**City of Toledo**  
**Zoning & Planning Committee**  
**Formal Agenda**

Wednesday, September 17, 2025

Request for a Special Use Permit for a Community Center for the property located at 601 Junction Avenue (SUP25-0022). Plan Commission recommends approval, subject to 42 conditions. (District 3)

Request for a Special Use Permit for a new Community Center for the property located at 2405 Stickney Avenue (SUP25-0021 ). Plan Commission recommends approval, subject to 33 conditions and 1 waiver. (District 4)

## SITE PLAN B

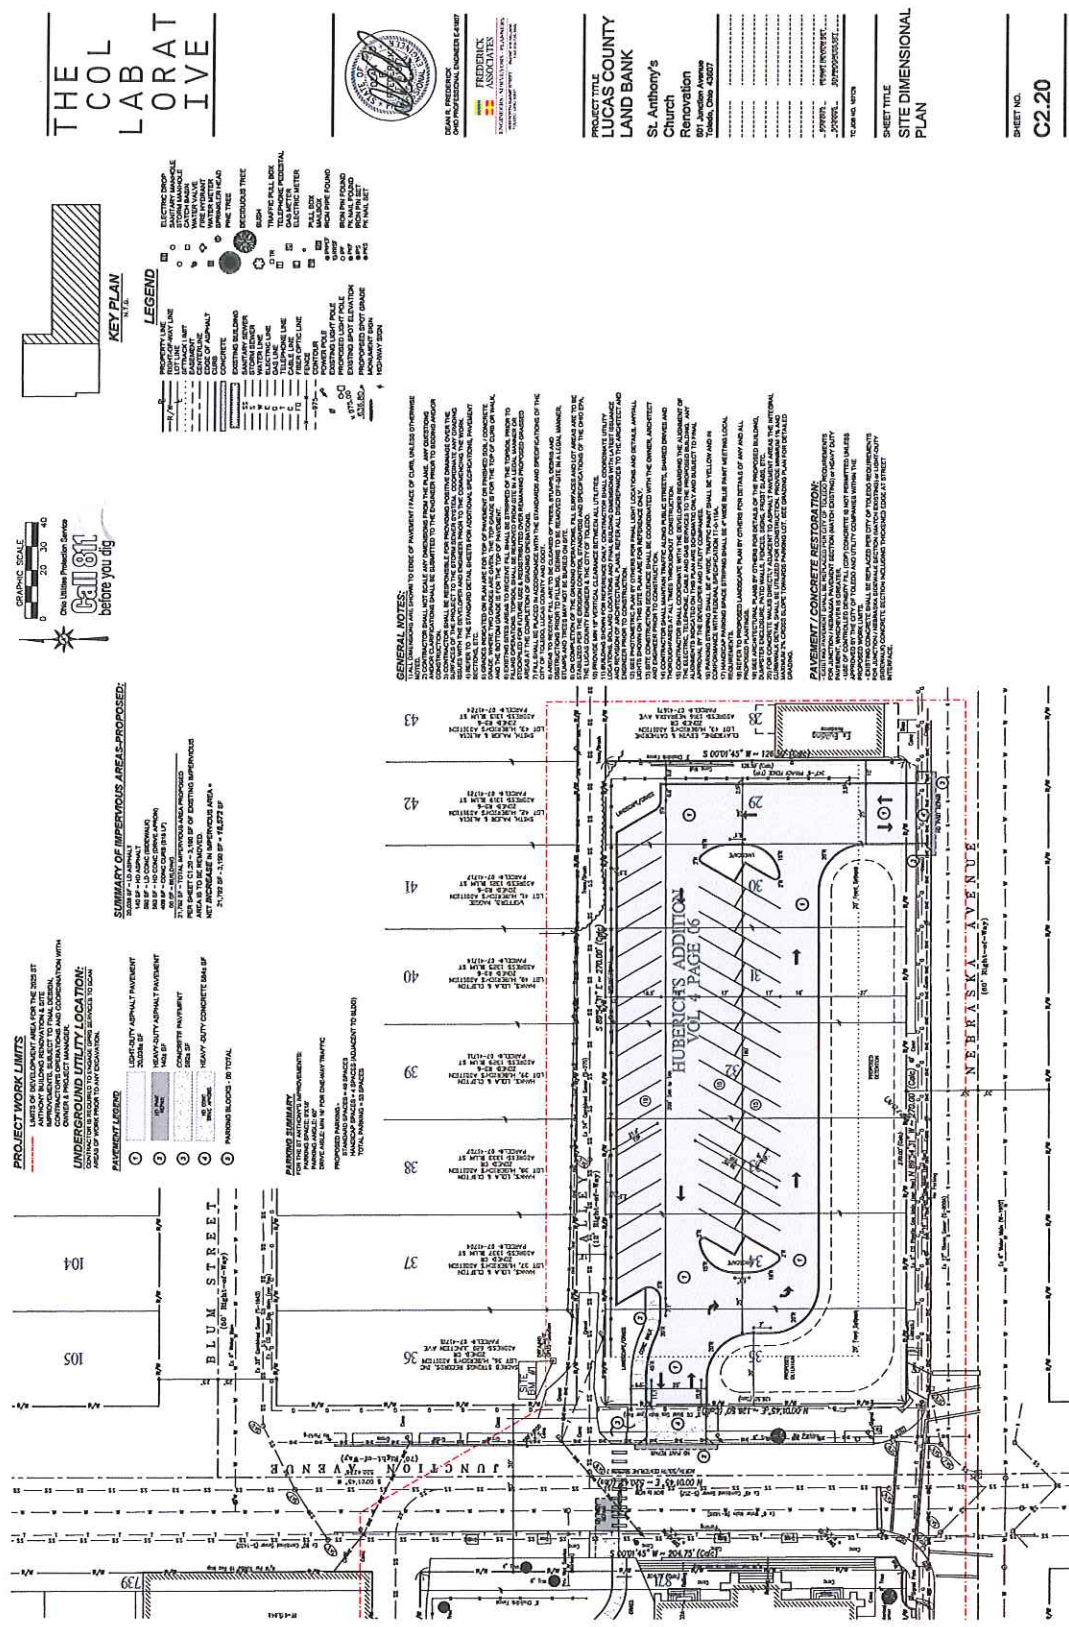
All auto accessible parking spaces must have a five foot (5') loading aisle per TMC§1107.1702(A). One (1) of the proposed accessible spaces is missing this loading aisle. The addition of this aisle on a revised site plan has been included as a condition of approval.

The Division of Traffic Management has objected to the proposed driveway access onto Junction Avenue and believes that effective parking lot access can be achieved solely off of Nebraska Avenue. Should access to Junction Avenue be desired, the applicant may be able to gain access via the existing alley – although they would have to improve the alley in order to do so. The removal of the proposed Junction Avenue driveway access has been included as a condition of approval. This condition goes on to permit the applicant to access the adjacent alley subject to review and approval by the Plan Director and Division of Traffic Management.

# LANDSCAPE PLAN

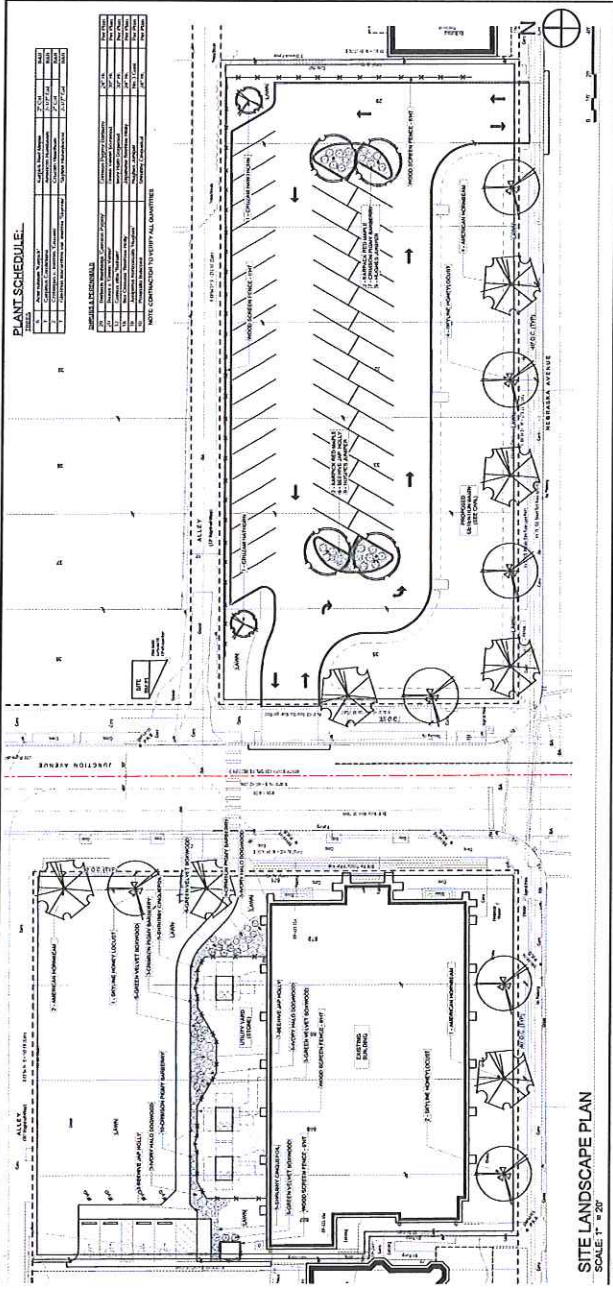
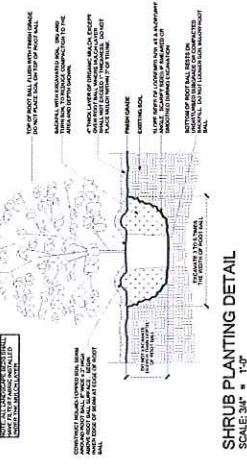
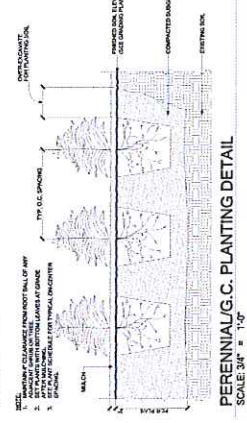
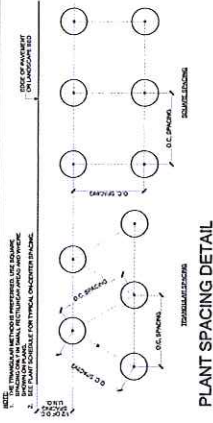
TMC§1108.0202 *Frontage Greenbelt* requires a fifteen foot (15') wide frontage greenbelt along both Junction Avenue and Nebraska Avenue. At least one (1) tree is required within these frontage greenbelts for every thirty feet (30') of frontage. Four (4) trees are required along Junction Avenue and nine (9) trees are required along Nebraska Avenue. The site plan depicts thirty-foot (30') wide frontage greenbelts with two (2) trees along Junction Avenue and six (6) trees along Nebraska Avenue. Five (5) additional trees are required within these frontage greenbelts. The addition of these required trees on a revised landscape plan has been included as a condition of approval.

TMC§1108.0202 *Frontage Greenbelt* also requires a solid evergreen hedge planting within the frontage greenbelts when abutting a parking lot. Low, undulating (horizontal and vertical) earth berms or decorative stone or brick walls (no concrete block), or ornamental metal fencing or combinations thereof may also be approved by the Planning Director. None of these options have been proposed; however, it is required in order to screen the parking lot. The addition of a frontage greenbelt screen – whether evergreen shrubs or another method approved by the Planning Director – on a revised landscape plan has been included as a condition of approval.

A Type A landscape buffer is required along the parking lot's eastern property line per TMC§1108.0203 due to the adjacent property's Duplex Residential (RD6) zoning classification. A ten foot (10') wide landscape area with a solid fence or wall with a minimum height of six feet (6') is required in this area. Four (4) trees and fifteen (15) shrubs are required for every 100 linear feet. As such, five (5) canopy trees and nineteen (19) shrubs are required within this eastern Type A buffer area. No trees or shrubs are shown on the landscaping plan within the provided ten foot (10') wide landscape buffer. The addition of these trees and shrubs on a revised landscape plan has been included as a condition of approval.

TMC§1108.0204 *Parking Lot Landscaping* requires two (2) canopy trees and six (6) shrubs for every ten (10) parking spaces within a parking lot. Ten (10) trees and thirty (30) shrubs are required in this forty-nine-space (49) parking lot. Six (6) trees and thirty-three (33) shrubs are shown on the landscaping plan. The addition of these required interior parking lot trees has been included as a condition of approval.

32. Pursuant to TMC§1108.0202 the frontage greenbelts along Junction and Nebraska Avenues adjacent to the proposed parking lot require least one (1) tree for every thirty feet (30') of frontage. **Not acceptable as depicted. A revised landscape plan shall be submitted to the Plan Director depicting at least four (4) trees within Junction Avenue greenbelt and nine (9) trees within Nebraska Avenue greenbelt.**

33. Pursuant to TMC§1108.0202 the frontage greenbelts along Junction and Nebraska Avenues adjacent to the proposed parking lot require a solid evergreen hedge planting. Low earth berms, decorative stone or brick walls, ornamental metal fencing, or combinations thereof may also be approved by the Planning Director. **Not acceptable as depicted. A revised landscape plan shall be submitted to the Plan Director depicting an acceptable screen within the Junction Avenue and Nebraska Avenue greenbelts.**

35. A Type A landscape buffer is required along the parking lot's eastern property line pursuant to TMC§1108.0203. Four (4) canopy trees and fifteen (15) shrubs are required for every 100 linear feet. **Not acceptable as depicted. A revised landscape plan shall be submitted to the Plan Director depicting at least five (5) canopy trees and nineteen (19) shrubs within this type A buffer.**

36. Two (2) canopy trees and six (6) shrubs are required for every ten (10) parking spaces within the parking lot pursuant to TMC§1108.0204. **Not acceptable as depicted. A revised landscape plan shall be submitted to the Plan Director depicting at least ten (10) trees and thirty (30) shrubs within or adjacent to the parking lot.**

# ELEVATIONS

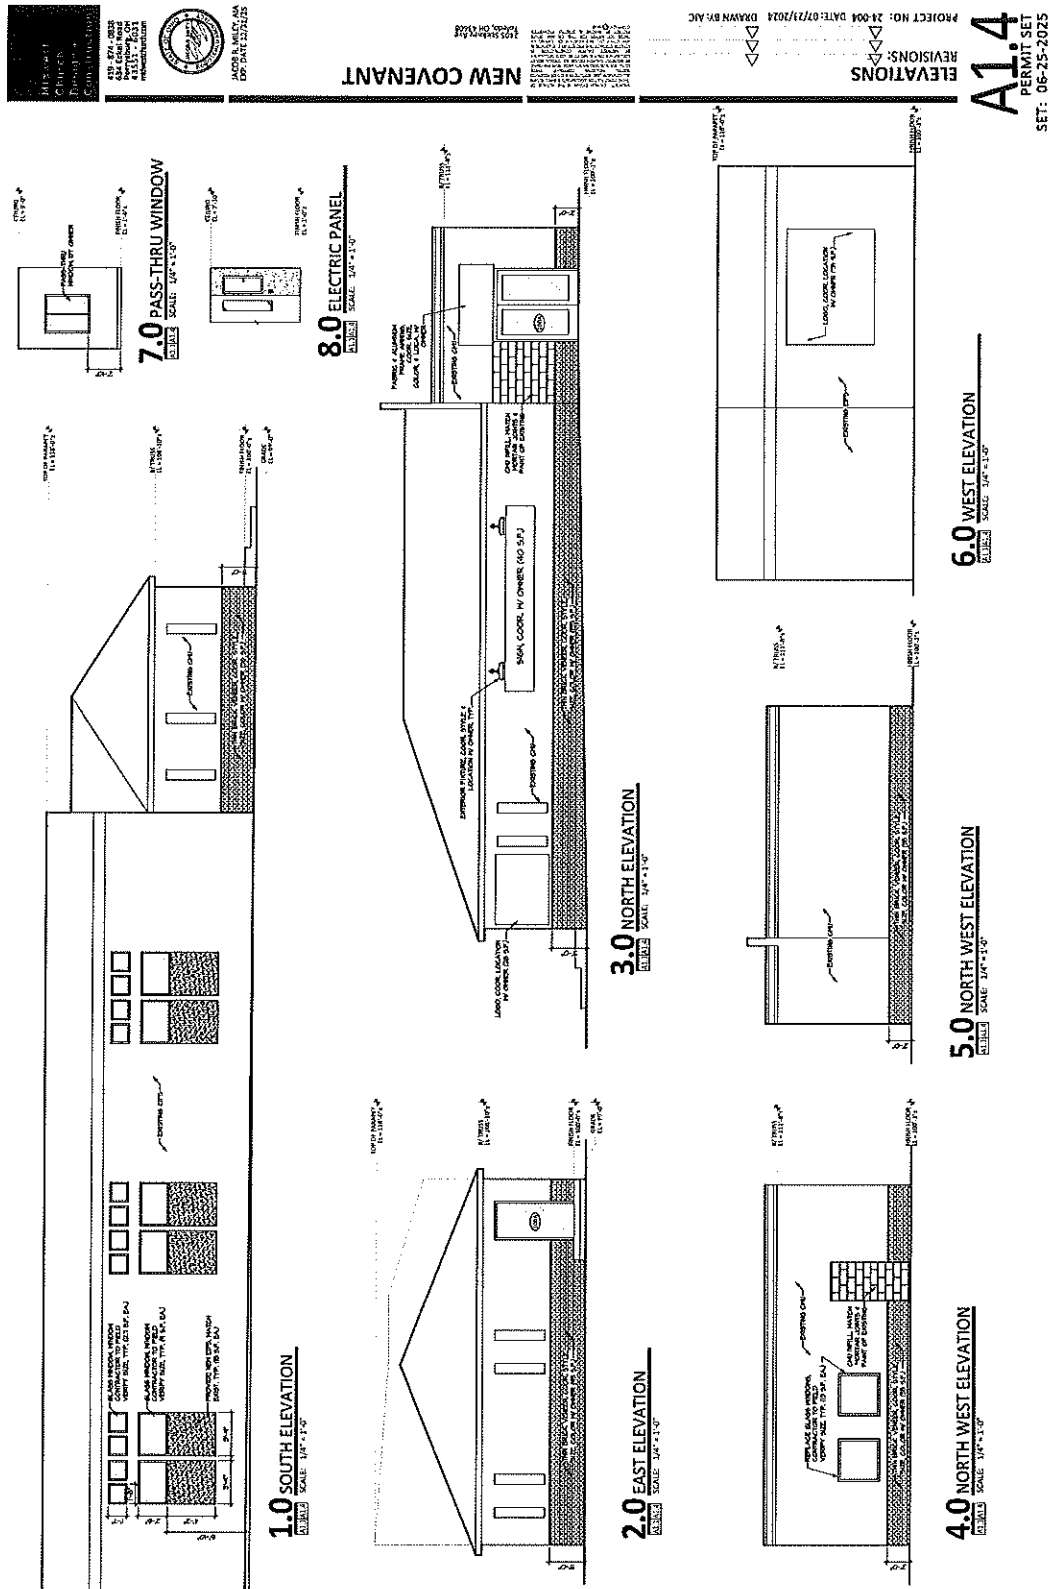
26. Proposed modifications to the existing structure may not increase its level of nonconformity with TMC§1109.0500, except as waived. **Not acceptable as depicted. Revised elevations shall be submitted to the Plan Director depicting no portion of any façade which was not previously an accent material being replaced/filled with an accent material, except as waived.**

# SITE PLAN

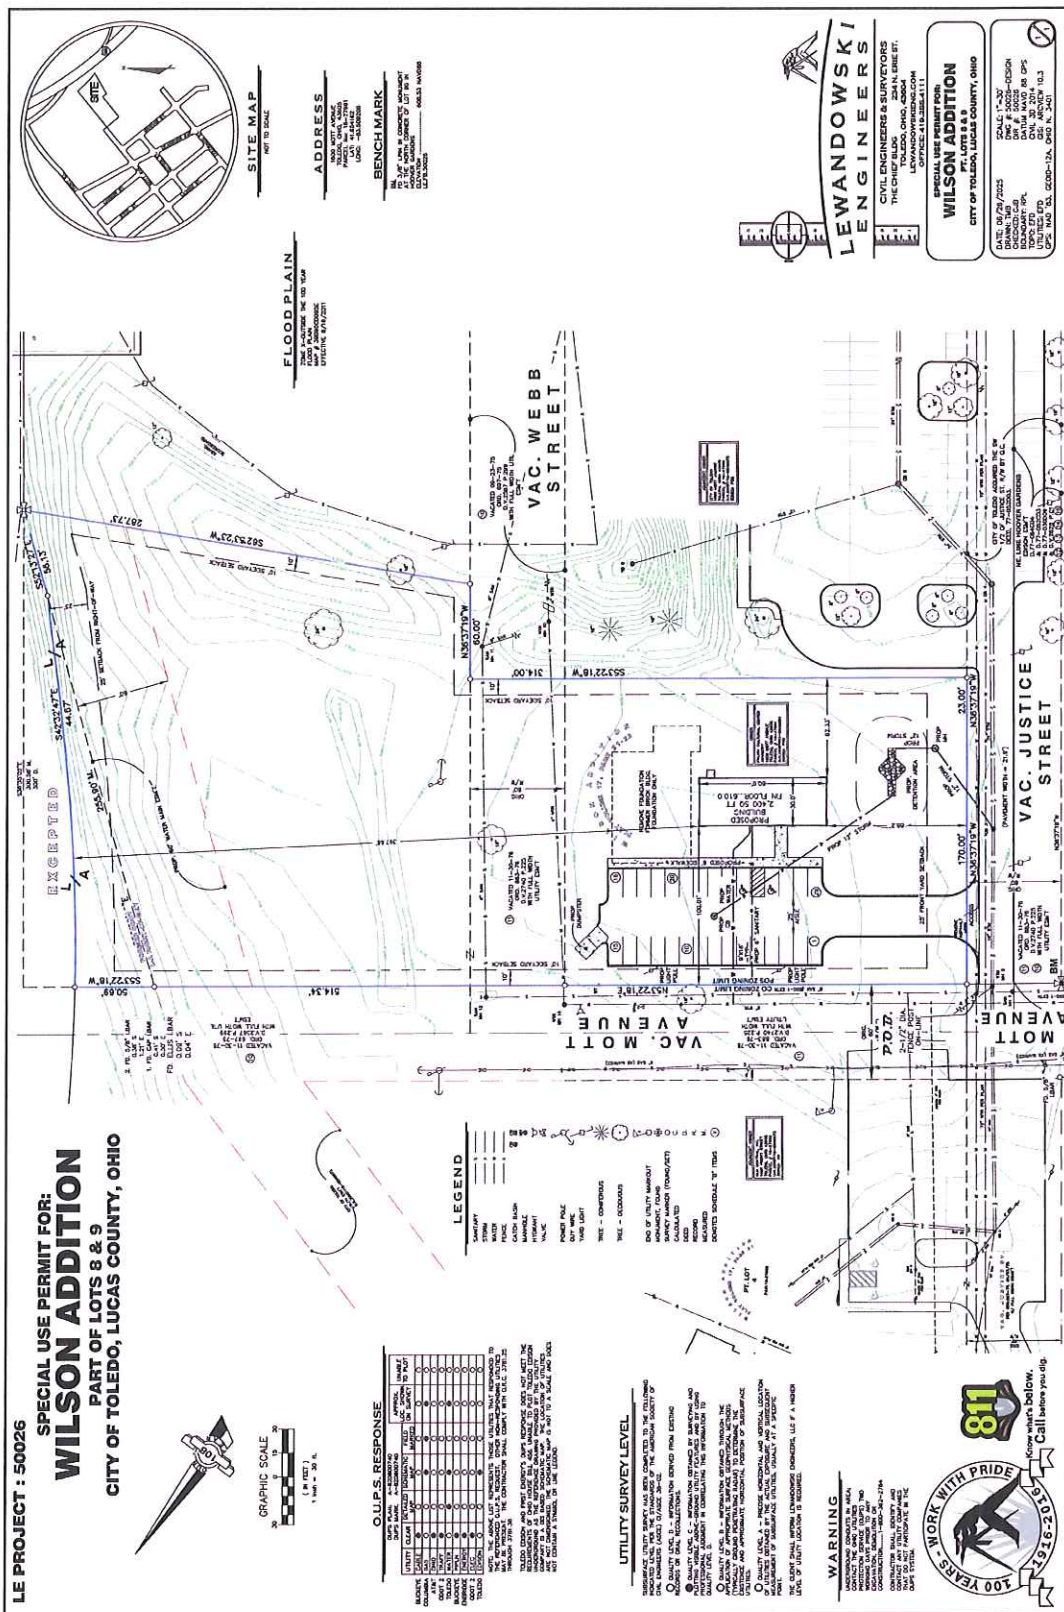
Pursuant to TMC§1107.0300 - *Off-Street Parking Schedule "A"*, Cultural Exhibits require one (1) parking space per 1,000 square feet. The proposed building area of 2,400 sq ft., requires a minimum of three (3) parking spaces. The site plan proposes twenty-six (26) spaces, exceeding the maximum allowed of five (5) spaces. Adjacent to the site is the Ravine Park II parking lot containing an estimate of three-hundred and four (304) parking spaces. An alternative parking plan shall be submitted to justify the need of excess parking pursuant to TMC§1107.400 B.

Bicycle parking is required pursuant to Off-Street Parking Schedule "A" (TMC§1107.0300). A minimum of one (1) bicycle space shall be provided per ten (10) automobile parking spaces. The parking lots contain a total of 26 spaces, requiring at least three (3) bicycle parking spaces. The submitted site plan does not depict any bicycle parking; this omission shall be addressed in revised site plans and is listed as a condition of approval.

30. Staff requests connecting sidewalks to be installed as proposed in SUP-12003-24, and which was approved by Ord. 143-23.
31. Per TMC§1107.0600 – Off Street Parking Schedule “A,” the minimum number of parking spaces required for a cultural exhibit is 1 per 1,000 square feet of floor area. Applicant is required to provide a minimum of three (3) spaces for 2,400 square feet. Pursuant to TMC§1107.0302 parking shall not exceed a maximum of 150% of the minimum, except through an approved alternative parking plan. **Site plans propose twenty-six (26) spaces, exceeding the maximum allowed. An alternative parking plan shall be submitted pursuant to TMC1107.0400.**

# LANDSCAPE PLAN

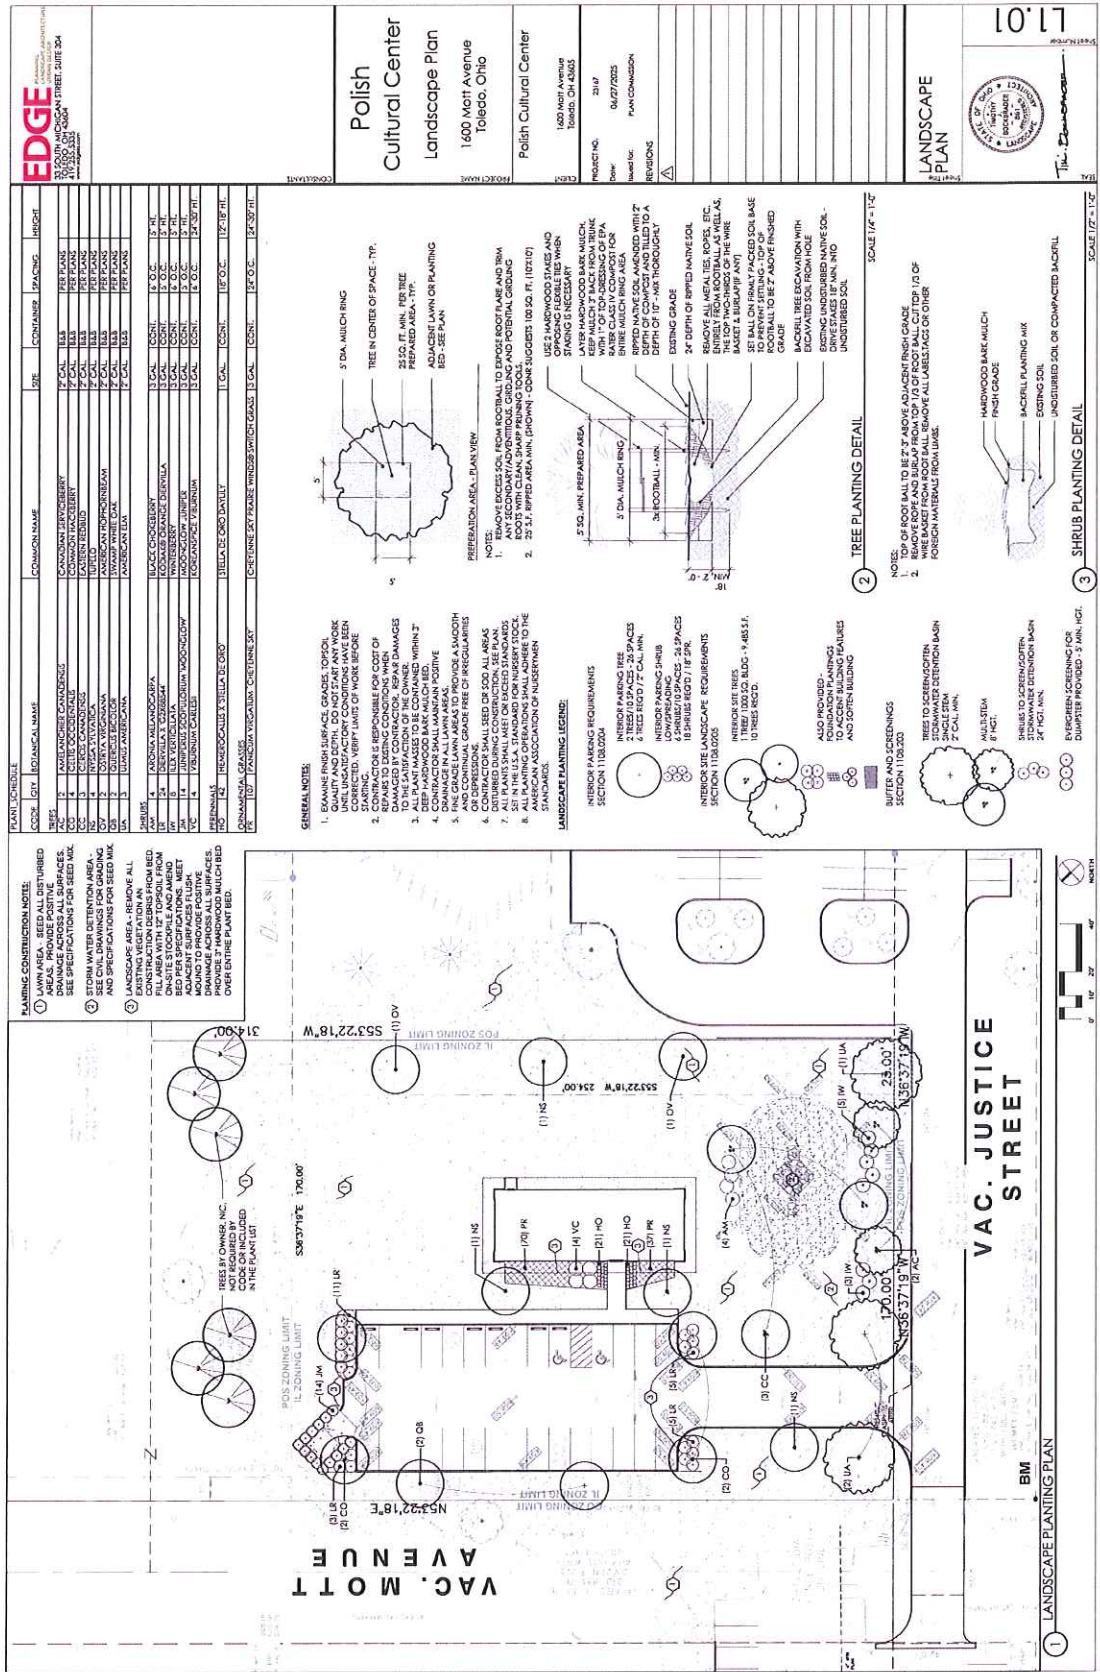
Furthermore, the POS zoning distinction does not trigger any screening requirements between abutting properties as per TMC§1108.0203 – *Buffer and Screening Requirements*. However, the site plan depicts a greenbelt along the southwestern edge of the parcel to screen the proposed stormwater detention basin. This greenbelt is comprised of five (5) trees and a continuous shrub row and is acceptable as depicted. Screening comprised of five-foot (5') evergreens is also depicted surrounding three (3) sides of the proposed dumpster. These plantings will be accompanied by a fence or wall structure surrounding all four (4) sides of the dumpster, as required by TMC§1108.0203(G), and shall be shown on a revised plan.

Interior parking lot plantings, as specified in TMC§1108.0204, must provide two (2) canopy trees and six (6) shrubs for each ten (10) parking spaces. With twenty-six (26) proposed spaces, the required interior planting area must be comprised of at least six (6) trees and sixteen (16) shrubs. The current site plan depicts six (6) trees and twenty-four (24) shrubs and is acceptable as depicted. In addition, perimeter parking lot plantings are required to visually screen parking facilities from view of Residential districts and public right-of-ways. A minimum of at least one (1) canopy tree must be provided for each thirty (30) linear feet, plus a continuous shrub with a minimum height of eighteen (18) inches. Plans depict adequate perimeter parking plantings to screen the parking lot from the Residential district to the southwest.
